City of Portland Design Commission

Design Advice Request

SUMMARY MEMO

Mailed: November 19, 2021
Date: November 17, 2021
To: James Casey McGuirl | McGuirl Designs & Architecture
From: Arthur Graves, Design Review
503.865.6517, Arthur.Graves@portlandoregon.gov
Re: EA 21-073704 DAR – Market Street Apartments at 1541 SW Market Street
Design Advice Request Memo for September 23, 2021

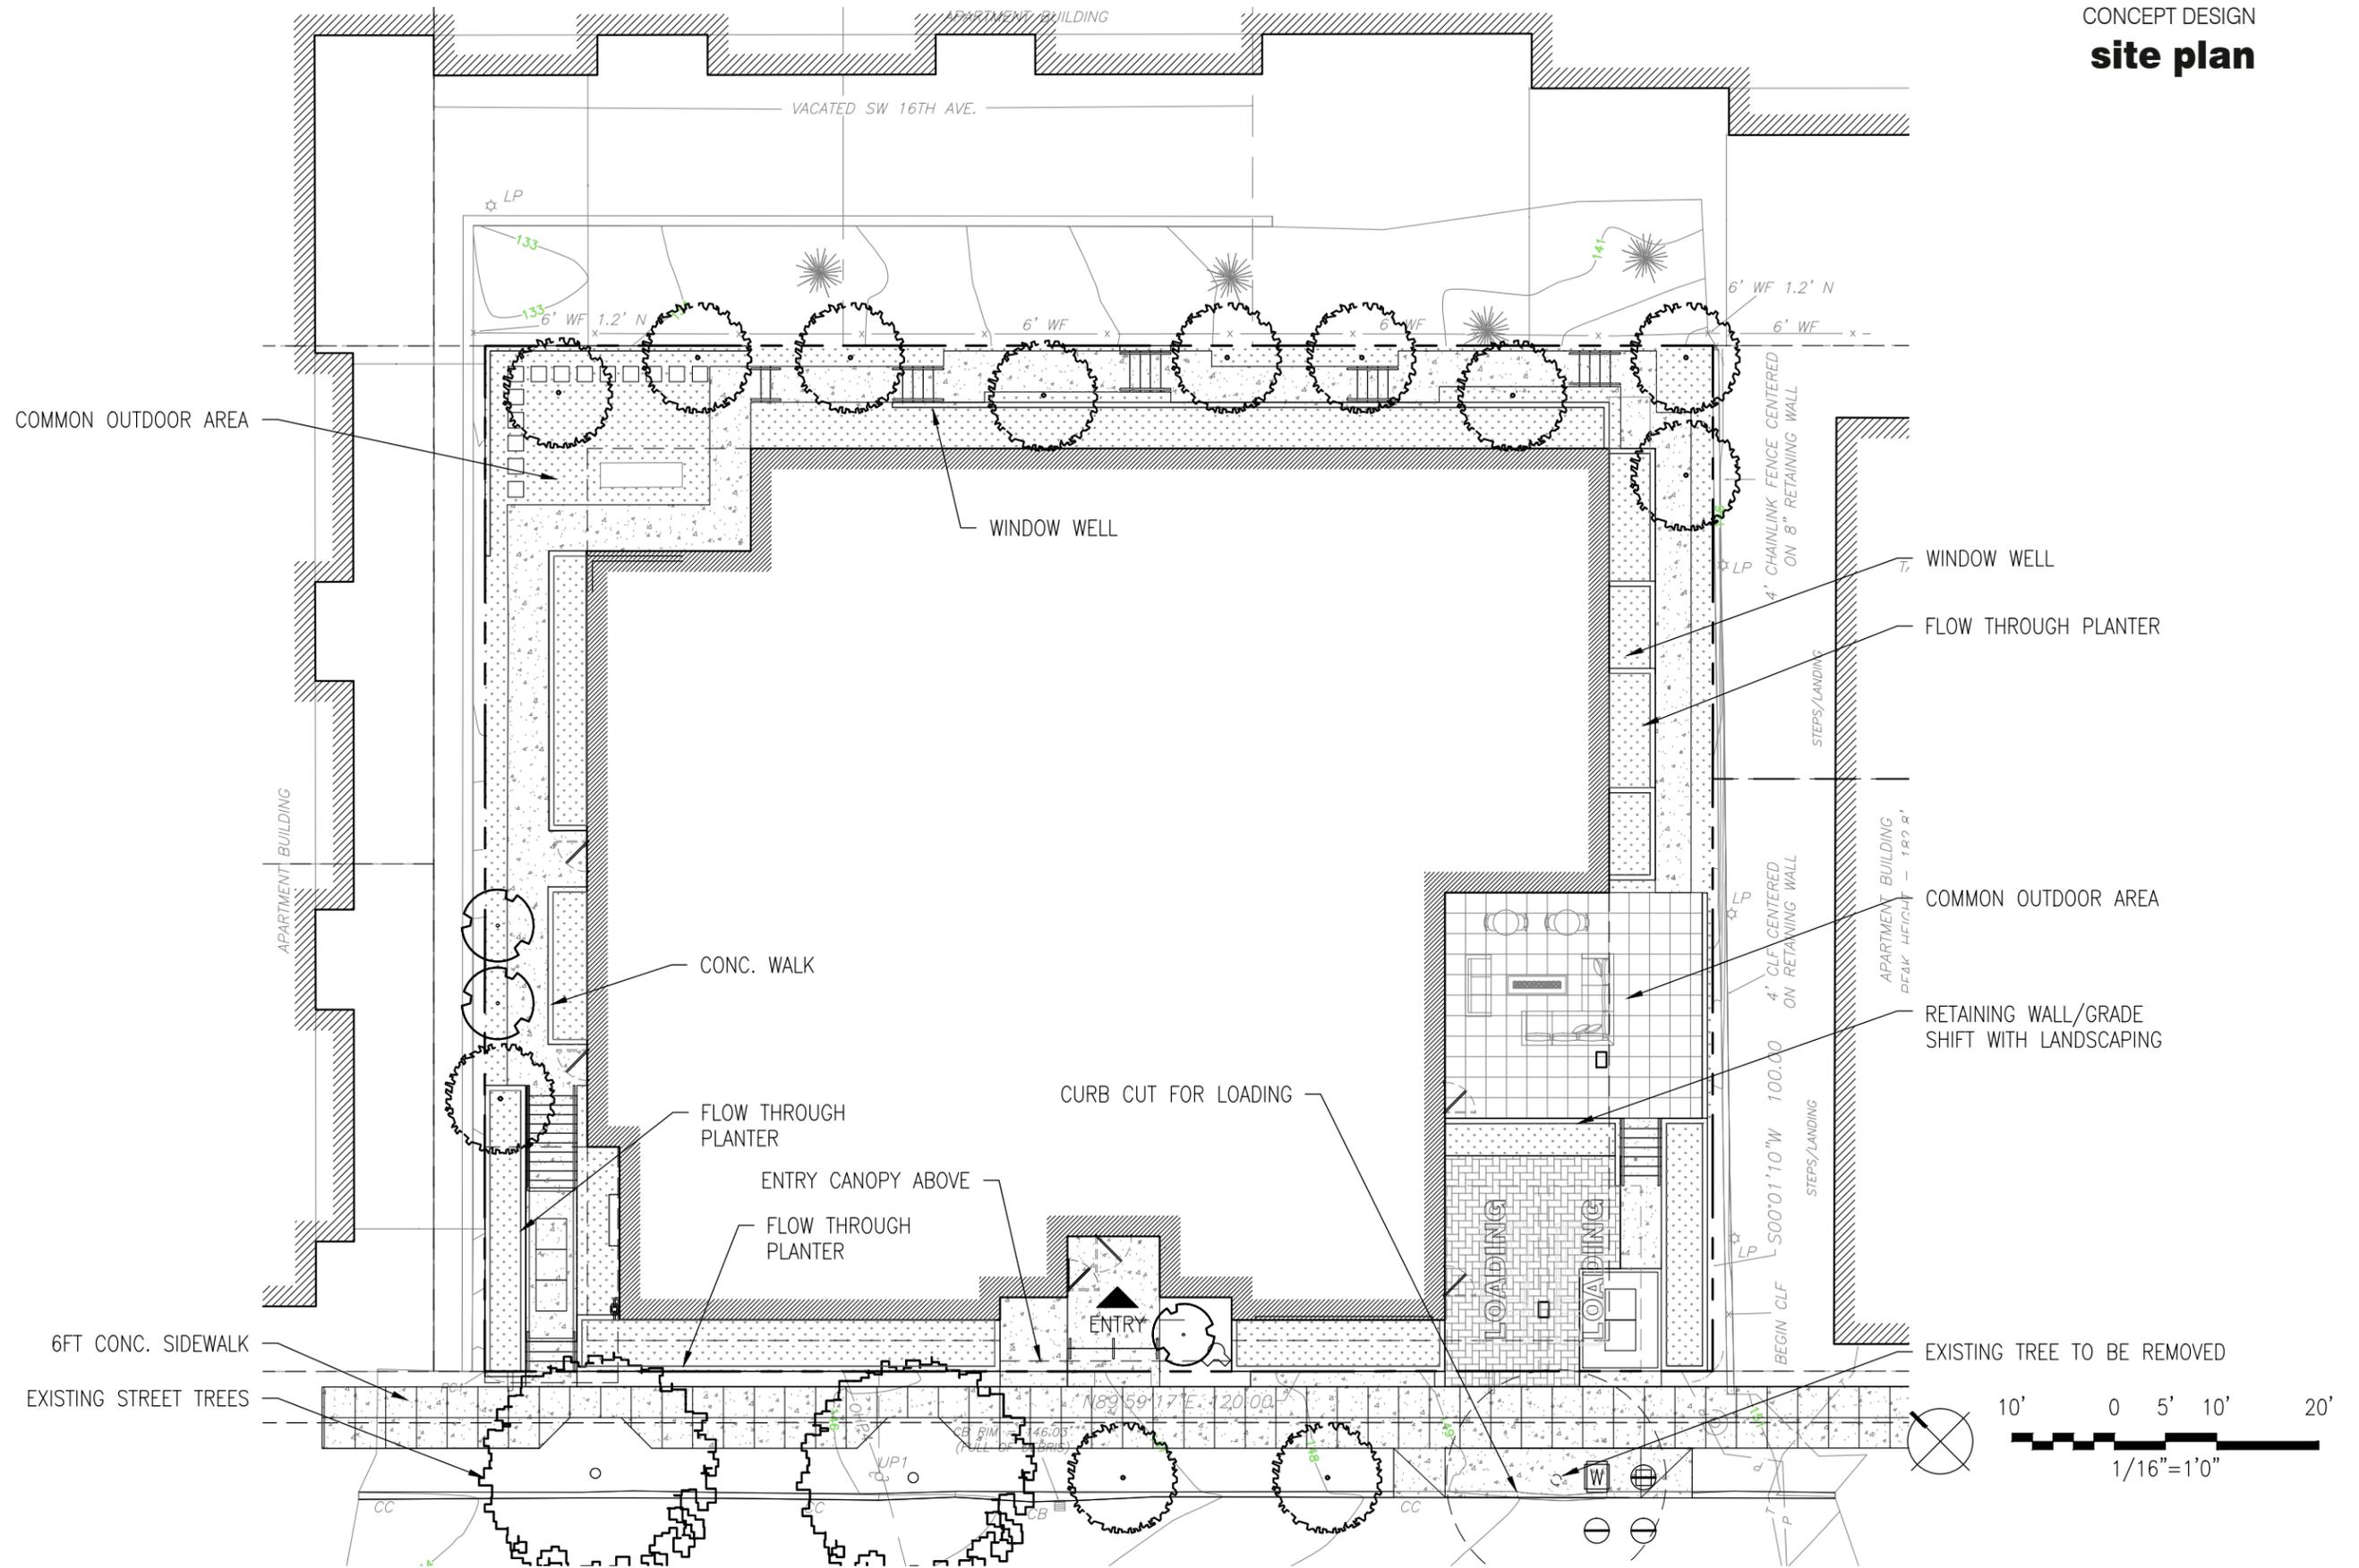
Planning/Zoning Comments:
 Front facade, in particular the ground floor, must provide clear physical and visual connectivity.
 Ground floor program has competing entrances with loading, trash, and main entrance.
 Lone dwelling unit should be removed from street side.
 Increase glazing for active uses.

Planning/Zoning Response:
 Building ground level more aligned with street entrance and not submerged.
 Ground floor program reduced quantity of competing entrances to only the main entrance and have placed the loading zones on the exterior.
 Dwelling units removed from streetscape on ground level, to help activate streetscape
 Glazing increased significantly

Urban Forestry Response:
 Loading zones located to far east to better serve the building use and requires removing 1 existing street tree.

landscape/outdoor plan

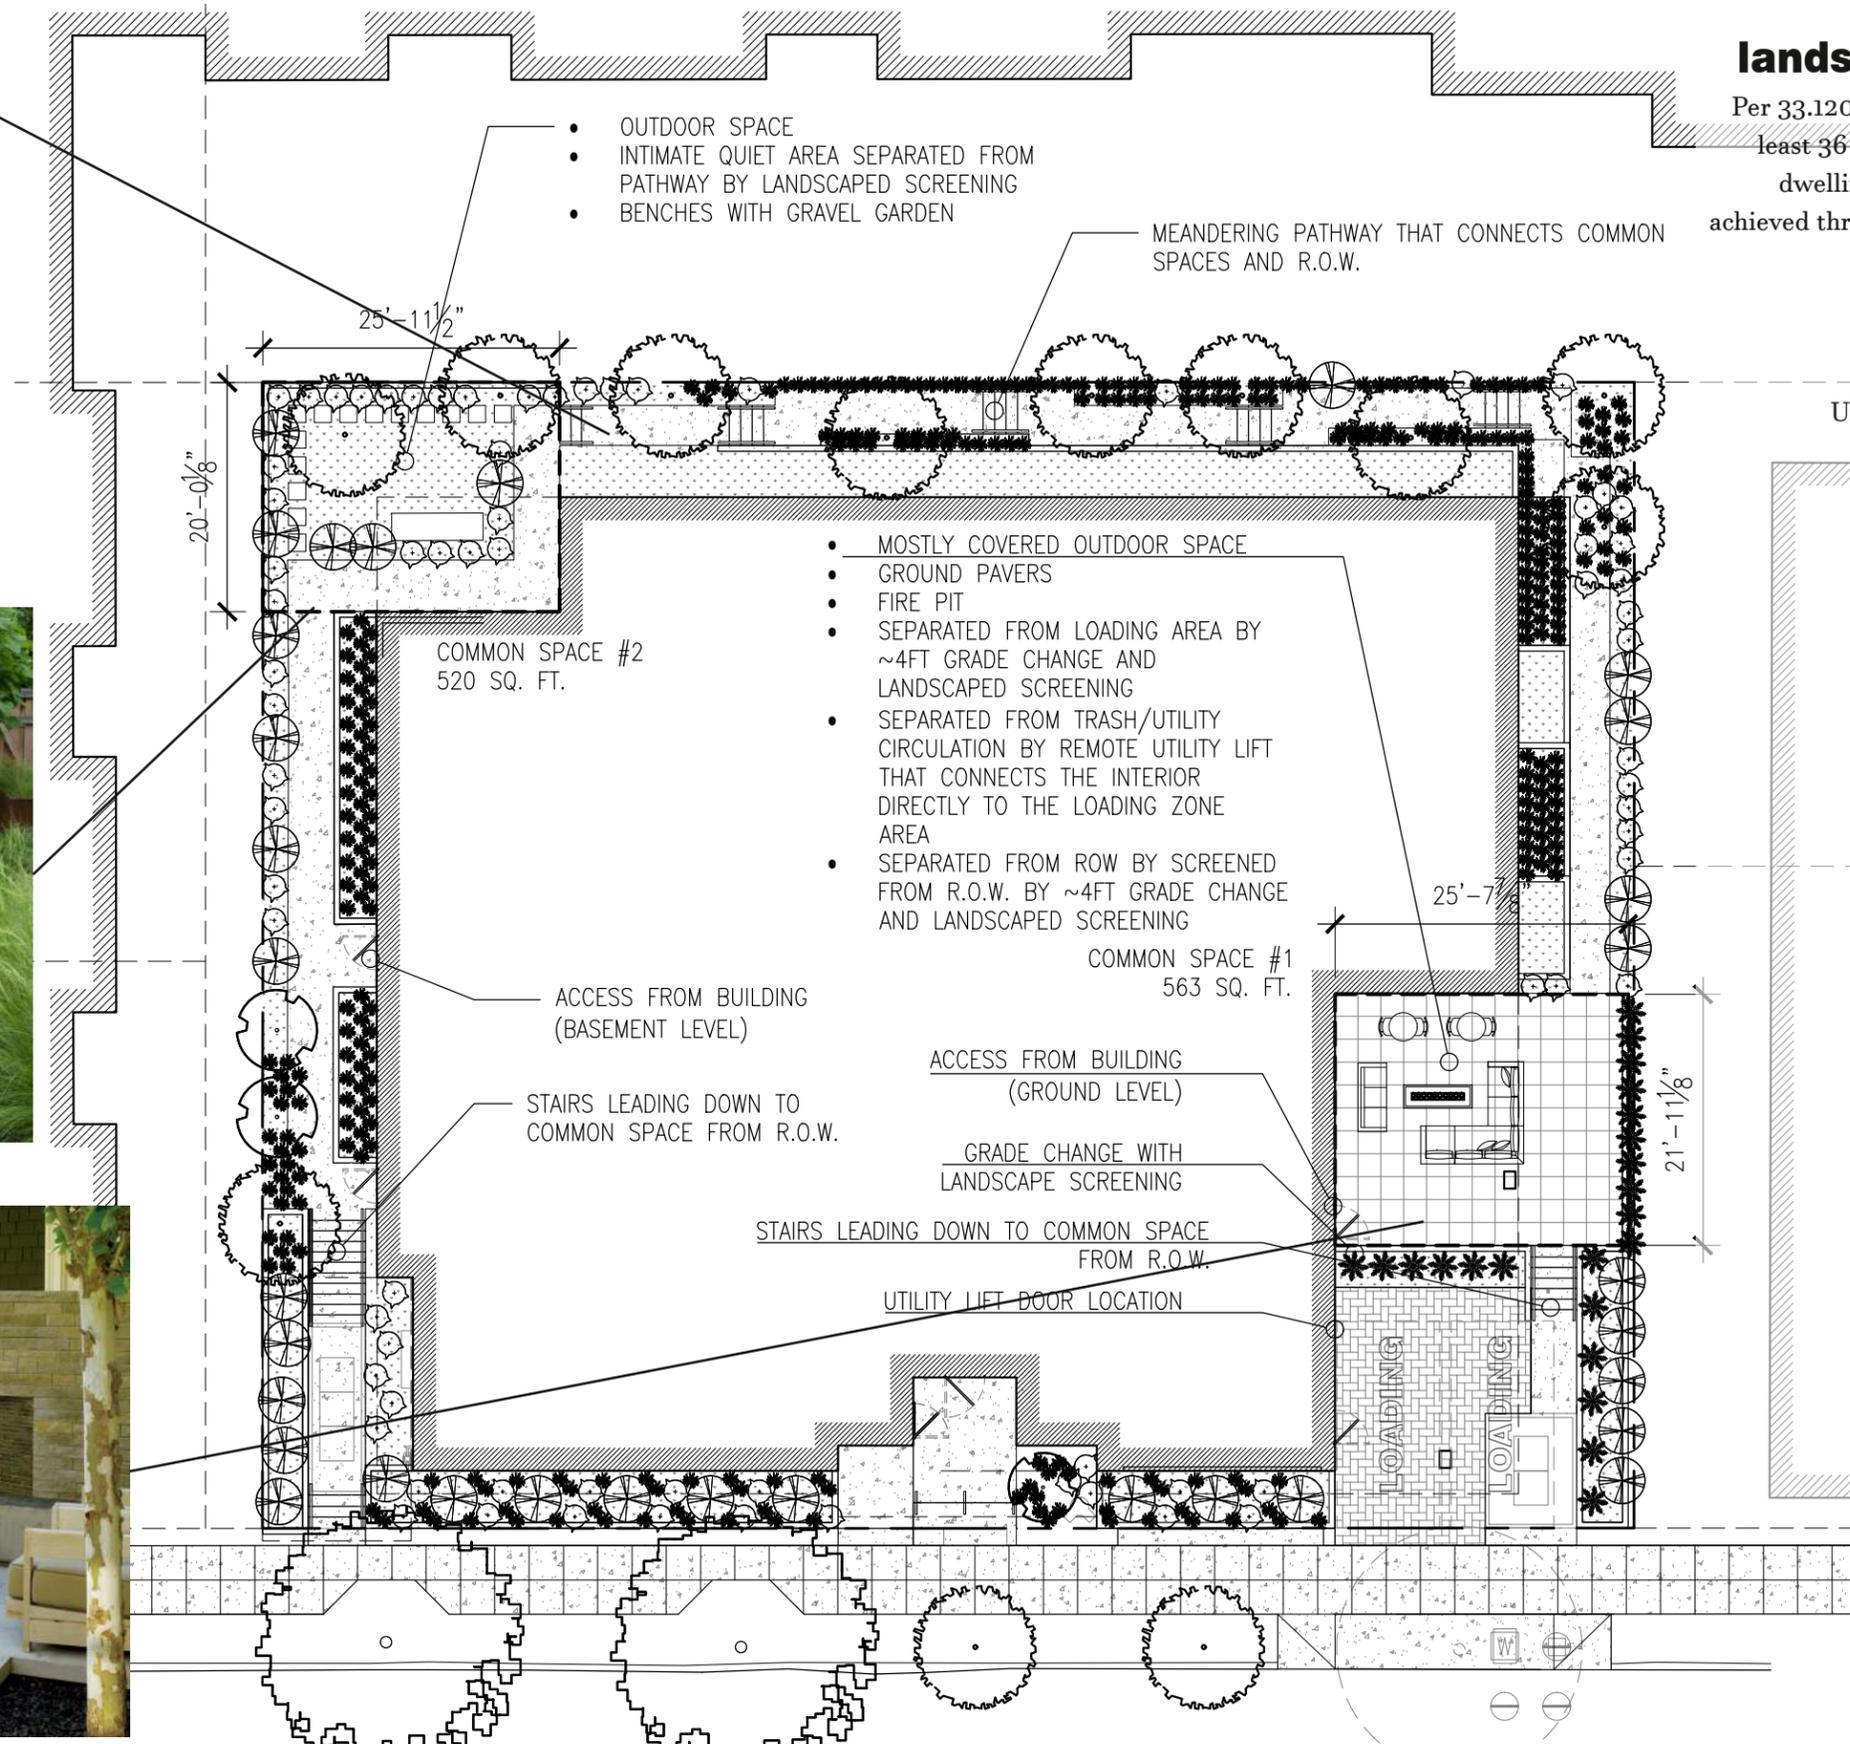
3. **Outdoor Areas:** Please provide additional information showing that this requirement is being met. Current Outdoor Areas lack clarity and do not appear to be integrated into the overall design.
4. **Materials proposed and Vents and other Mechanical wall penetrations;** Please provide additional information in revised drawings.
5. **Loading and Bike Parking:** As mentioned previously, proposed loading currently disproportionately dominates the street facing façade both due to the size and location of the loading doors.

Per 33.120.240, on sites up to 20,000 SF, at least 36 SF of outdoor area is required per dwelling unit. This requirement may be achieved through a combination of private and common areas.

Total Dwelling Units
133 Units
Units with individual outdoor space
63 Units (See plans)
Units utilizing Common Space
70 Units (See plans)
Required Common Space
2,520 SF

Provided Common Spaces
Common Space #1 (Outdoor)
563 SF
Common Space #2 (Outdoor)
520 SF
Common Space #3 (Level 01)
920 SF
Common Space #4 (Level 07)
544 SF
Total Common Space Provided
2,547 SF
